October 29, 2025

**RE: Request for No Substantial Changes Determination
Asbury Common
461 Asbury Street**

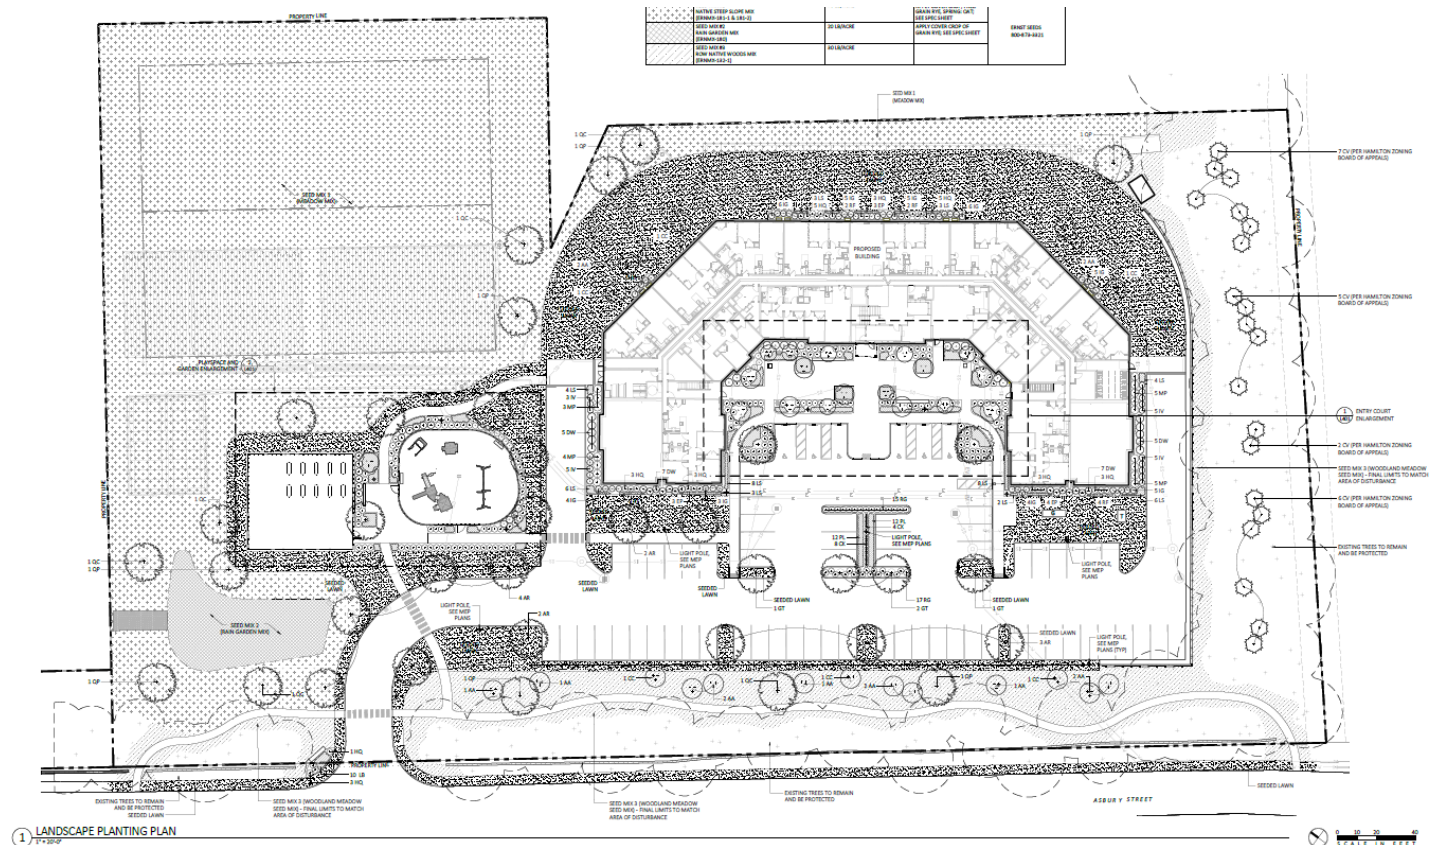
Changes shown in the 100% construction drawings include revised landscaping, reduced walking path, and removal of the rear terrace. The major elements of the development including the number of units, unit types, building location, building size, building layout, parking layout, entrance location, and the landscaping along Asbury Street and adjacent to the Canter Brook development remain substantially the same.

The portion of the walking path along Asbury Street has been tweaked to respond to existing trees that will be preserved. The material of this portion has been changed from concrete to stabilized aggregate to allow for better infiltration and to minimize potential damage to existing trees. The portion of the walking path adjacent to the Canter Brook development and around the rear of the building has been removed in response to Harborlight's property management department who has concerns around maintenance and liability. Residents will still be able to circulate around the building on paved and seeded areas.

The rear terrace has been removed in response to feedback from Harborlight's property management department and to improve the layout of the lowest level floorplan. Residents can still utilize the rear lawn area, but the formal outdoor gathering area has been emphasized in the front courtyard.
